Lower Thames Crossing

9.152 Responses to the Examining Authority's ExQ2 Appendix E – 9. Noise & Vibration

Planning Inspectorate Scheme Ref: TR010032
Examination Document Ref: TR010032/EXAM/9.152

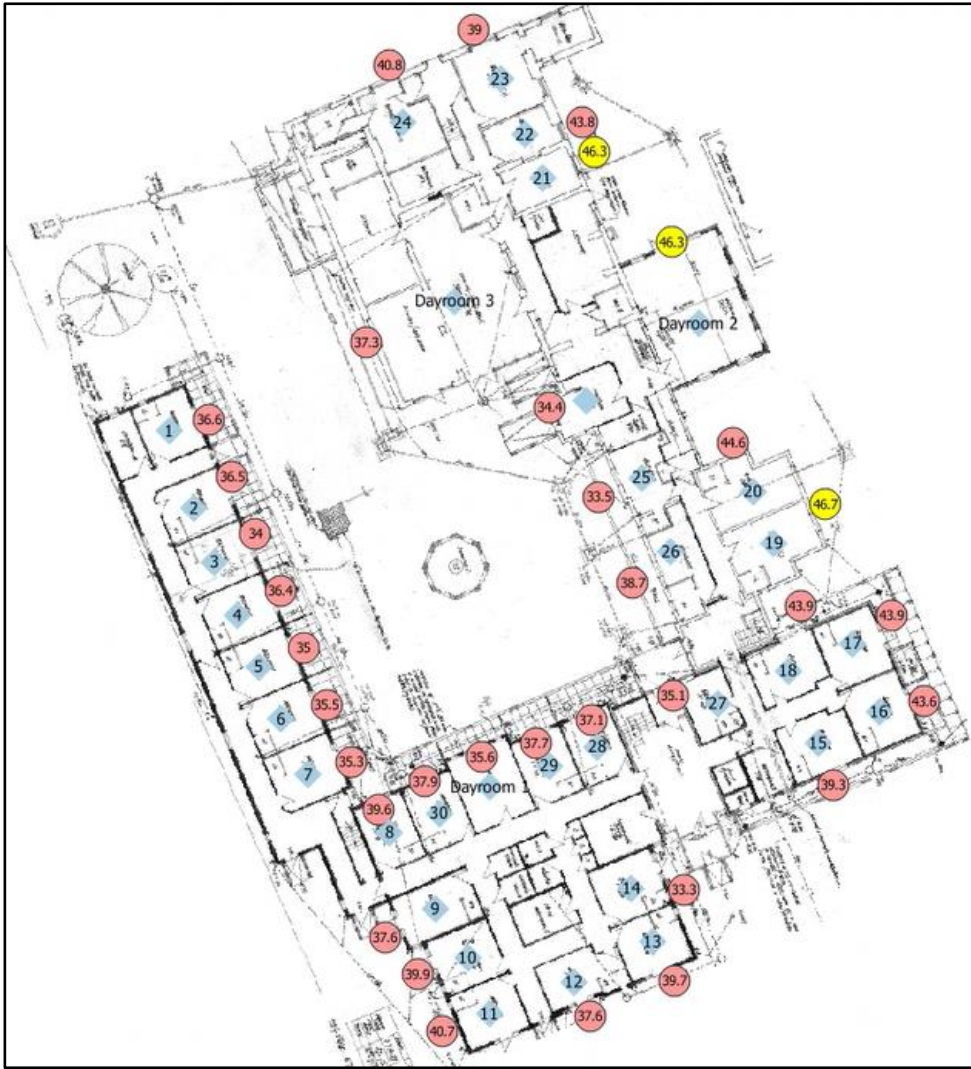
PINS ID	Question to	Question / Response
		<p>Utilities works OHT 4-7 and OH 6</p> <p>Whilst the noise model assumes this activity to occur in totality 24/7 for 11 months, it has now been confirmed by the construction team that information supplied by National Grid indicates only limited activities would occur during the overnight, and not the full works as assumed in the ES reasonable worst-case noise model. In addition, the information from National Grid confirmed that, within the total 18 months assumed for these works in the ES noise model, the 24/7 activities would likely not exceed 11 weeks for each set of works.</p> <p>Predominantly the works associated with OHT 4-7 and OH 6 would be during the core daytime hours, with the night-time activities limited to:</p> <ul style="list-style-type: none"> • Infrequent oversized and abnormal deliveries that cannot be accommodated during daytime hours • Positioning of protective netting over roads (it is noted that the supporting scaffolding works would be limited to daytime activities) • Commissioning and tensioning. <p>In addition to this the following BPM could be implemented in the works, and acoustic modelling has been undertaken to predict the noise levels at the care home with these measures implemented, presented below.</p> <ul style="list-style-type: none"> • The overhead line hydraulic tensioning plant could be located at more remote tower locations, thus increasing the separation distance to the care home. However, this has not been assumed in the modelling as it cannot be confirmed at this point with other issues needing to be considered aside from noise. • The tensioning rig enclosed in a 4-metre-high enclosure. • Limiting of the operational plant overnight to only that required to support the tensioning works. <p>As these measures are limited to the work site, and are significantly removed from the care home facility they are not considered to have any detrimental physical effects on the residents.</p> <p>Earthworks construction of the permanent bund to the west of the care home</p> <p>As this activity is noted as earthworks it would fall under the Project commitment to undertake no earthworks activities within 300 metres of any sensitive receptor during the evening or overnight periods (as set out in Table 6.1: Working hours of control document ES Appendix 2.2: Code of Construction Practice [REP5-048], which will be secured by Environmental Management Plan 2 (EMP2)). As such this activity would not occur outside of core daytime hours.</p> <p>In addition to this the following BPM could be implemented in the works, and acoustic modelling has been undertaken to predict the noise levels at the care home with these measures implemented, presented below.</p>

PINS ID	Question to	Question / Response
		<ul style="list-style-type: none"> • Replacement of the diesel plant considered in the ES with electric alternatives reducing the noise levels generated by the plant. • Where electric plant options are not available provision of the quietest plant available to undertake the works. • Commitment to undertake no earthworks activities within 300 metres of any sensitive receptors during daytime and evening periods. • Provision of local temporary acoustic screens of 4 metre height between the activity and the care home. The screens would be relocated as necessary to screen works. • A 4m temporary acoustic fence along the western boundary of the care home site and within the Order Limits on the northern side of the A1013 Stanford Road. • Construction of the bund in such a way as to build an initial bund quickly and then work behind the bund. <p>As the majority of these measures are limited to the work site, and are significantly removed from the care home facility, they are not considered to have any detrimental physical effects on the residents. While the screening measures proposed in the vicinity of the care home would not alter the operation or quality of care at the facility, there is the potential for a perceptible change for existing residents and from the user experience for new residents.</p> <p>The mitigation is therefore designed to minimise disruption, but to also minimise imposing or intrusive perceptions that might modify resident behaviours or use of amenities at the care home. Please note that the most significant change will be the temporary acoustic barrier to the west of the care home, which runs parallel to a small number of bedrooms (3No. defined from schematic plans supplied by the care home) with westerly facing windows, and a corridor that serves 7 additional ground floor bedrooms, all with windows that face into the courtyard and no direct westerly views. This limits any potential impact from the proposed mitigation to a temporary perceptible change in 3 bedrooms (when in use), and for users of the corridor. This is not of a nature or magnitude sufficient to alter behaviours or use, or result in any impact to the range and quality of care, which would result in any measurable adverse health effect.</p> <p>In addition, consideration could be given to the potential for bringing the bund, or part of the bund, earlier in the programme subject to material availability; this would allow the bund to act as a significant screening feature for the care home for all following construction activities to the west including the main line works. However, this has not been considered in this study and is still being considered by the construction team.</p> <p>The proposed bund to the north of the facility is required to mitigate against operational noise, and runs behind the screening of the existing tree /shrub line and Stanford Road opposite the care home. The mitigation again has no impact on the operation of the facility, and perceptible changes from the adjacent</p>

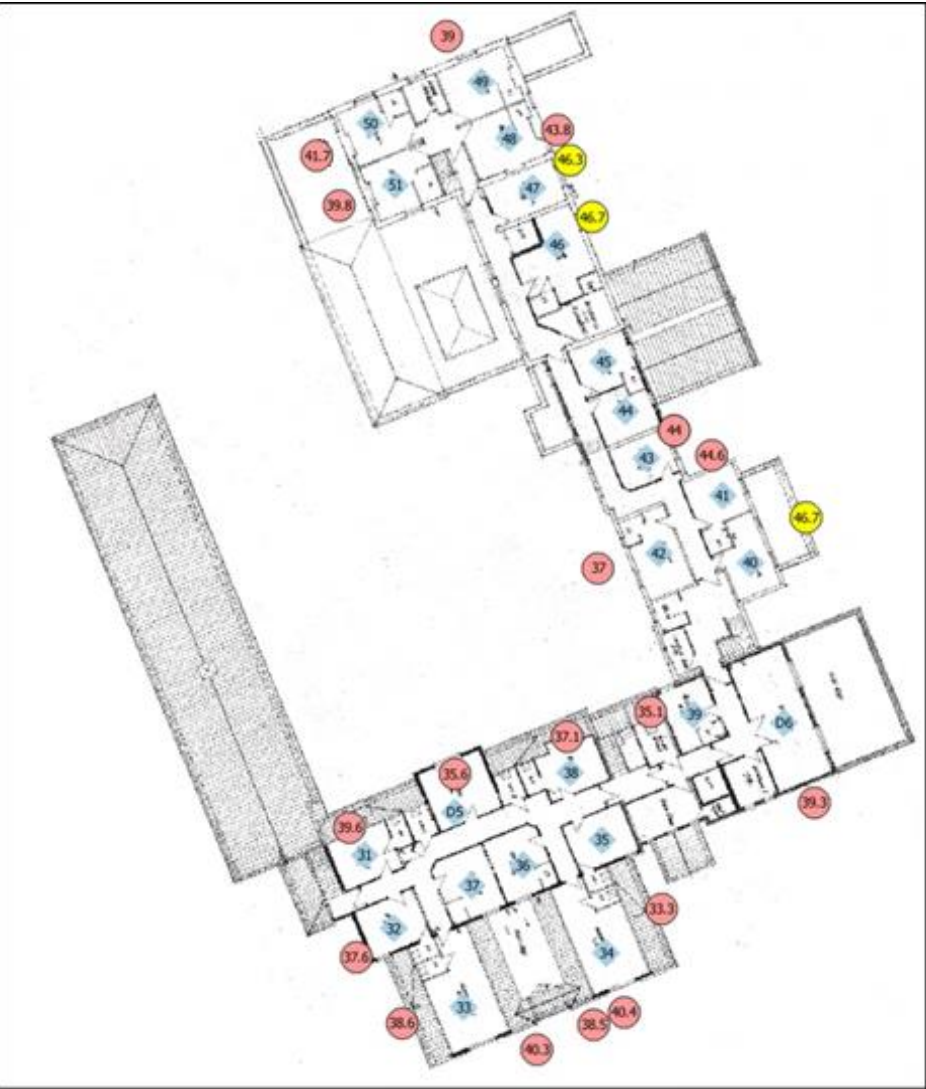
PINS ID	Question to	Question / Response
		<p>General consideration of all daytime construction activities that result in the significant effects at the care home in collaboration with the Construction team has concluded the following BPM measures are practical, and are representative of the measures that will be implemented through the implementation of the existing REAC commitments.</p> <ul style="list-style-type: none"> • Replacement of the diesel plant considered in the ES with electric alternatives reducing the noise levels generated by the plant. • Where electric plant options are not available provision of the quietest plant available to undertake the works. • Commitment to undertake no earthworks activities within 300 metres of any sensitive receptors during daytime and evening periods. • Provision of local temporary acoustic screens of 4 metre height adjacent to works and positioned between the activity and the care home. The screens would be relocated as necessary as works progress to screen works. • Provision of a 4-metre temporary acoustic fence or barrier within the Order Limits on the opposite side of Stanford Road with a lateral length of approximately 250m, required for the duration of the works on Stanford Road and until the new A1013 is tied into the old A1013 alignment and the new alignment is open to traffic, removed around Month 46. As approximately detailed on Plate 1. • Provision of a 4-metre temporary acoustic fence or barrier within the Order Limits on the western boundary of the care home site. <p>As the majority of these measures are limited to the work site, and are significantly removed from the care home facility they are not considered to have any detrimental physical effects on the residents. With regard to the proposed screens adjacent to the works and care home we would revert to the information presented above (within the section entitled “Earthworks construction of the permanent bund to the west of the care home”) regarding the potential for physical effects of this measure on the care home.</p>

PINS ID	Question to	Question / Response
		<p style="text-align: center;">Plate 1 Proposed temporary acoustic fencing/barriers at Whitecroft Care Home</p>  <p>Assessment of effectiveness of BPM measures</p> <p>Reassessment of the construction noise impacts presented in the ES, including the effectiveness of all of these measures, is discussed below. On the basis of the nature of the receptor this has been undertaken at the façades of the sensitive rooms during the overnight and in external spaces during the daytime, relative to the construction noise limits proposed and discussed in ES Chapter 12: Noise and Vibration [APP-150].</p> <p><i>(i) Night-time</i></p>

PINS ID	Question to	Question / Response
		<p style="text-align: center;">Plate 2 Ground floor – calculated night-time BPM construction</p>

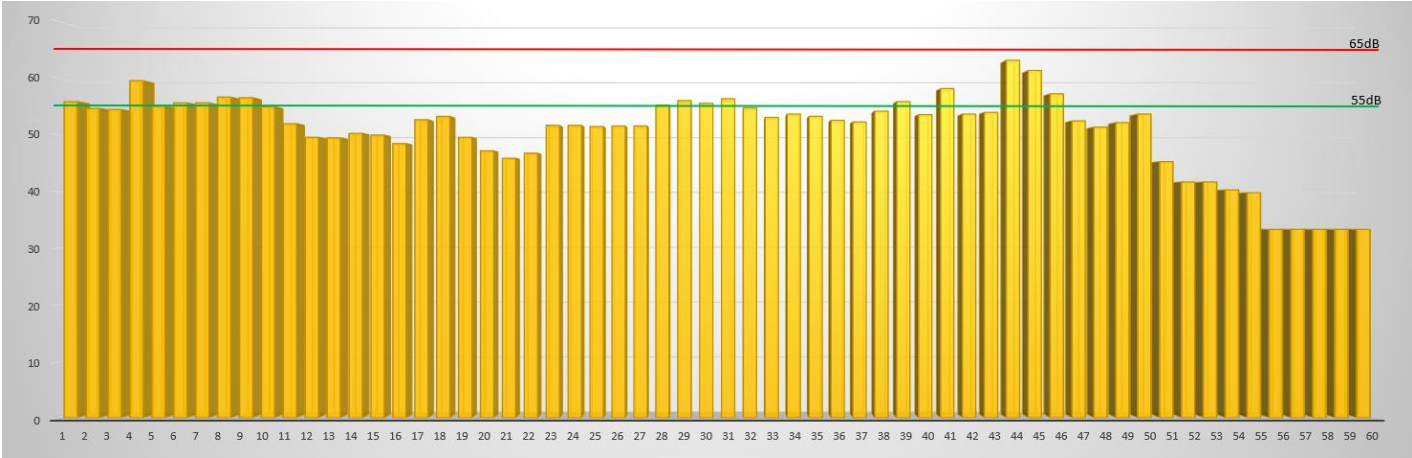
PINS ID	Question to	Question / Response
		<p>With the implementation of the above-noted BPM measures for the night-time in the noise model, the following façade construction noise levels are predicted across the care home. The night-time period has been considered on a room-by-room basis as a result of the concerns raised by the operator relating to night-time construction noise impacts.</p> <p>It is noted that the performance of temporary acoustic barriers has been modelled within the software.</p> <p>The information presented in Plates 2 and 3 below relates to the worst-case prediction for any month in the 60-month programme at the identified façade. It is noted that this level is not what the façade would be exposed to for the entire construction programme only in the worst-case month; all other months would present lower construction façade noise levels. Where there is a breach of the 45dB Night-time SOAEL, as defined in the DCO application, this is discussed in more detail below.</p> <p>Plate 2 relates to the ground floor and Plate 3 to the first floor. Where the façade noise level is identified in yellow this denotes a breach of the 45dB criteria at that façade.</p>

PINS ID	Question to	Question / Response
		<p>Consideration of the information within Plates 2 and 3 above, produced by detailed consideration and modelling of the proposed BPM measures, concludes that:</p> <ul style="list-style-type: none"> • Only ground floor and first floor façades on the eastern elevation of the care home have the potential to breach the 45dB threshold for night-time activities. • Analysis of the information on a month-by-month basis concludes that the 45dB criteria is only breached in one month during the five-year construction period, when the eastern tie in works on the A1013 are undertaken. Other than this the construction noise assessed on the care home is below the 45dB criteria as a result of the mitigation proposed: <ul style="list-style-type: none"> – Month 46 when the A1013 tie in works are undertaken. These are required to be undertaken at night to minimise traffic disruptions but would be for only ‘1No. 48hr weekend possession’. – As such these breaches are predicted to only actually occur for two nights in the five-year construction programme. • No other breaches of the 45dB criteria are predicted in the mitigated scenario at the care home due to other night-time activities as a result of the BPM measures implemented in the noise model including increases in screening and separation distances. <p>Consideration of the information presented in Plates 2 and 3 above concludes that, subject to the mitigation measures presented in this response, construction noise is predicted to be below 45dB on all façades of the care home for 59 of the 60 months of the construction programme.</p> <p><i>(ii) Day-time</i></p> <p>With the implementation of the above BPM measures for the daytime works in the noise model the following construction noise levels are predicted at the care home.</p> <p>It is specifically noted that in the modelling where temporary acoustic fencing/barriers are proposed these have been included within the noise model and the performance of such calculated by the software in accordance with appropriate methodologies.</p> <p>Details of the monthly daytime construction noise levels at the care home including the consideration of the prescribed mitigation measures are presented in Plate 4 below, along with a green line which represents the 55dB upper daytime health effect criteria from the World Health Organization (WHO) as advocated by the Acoustic Consultant acting on behalf of the care home, and a red line which represents the appropriate BS5228¹ construction noise limit for this receptor advocated by the applicant.</p>
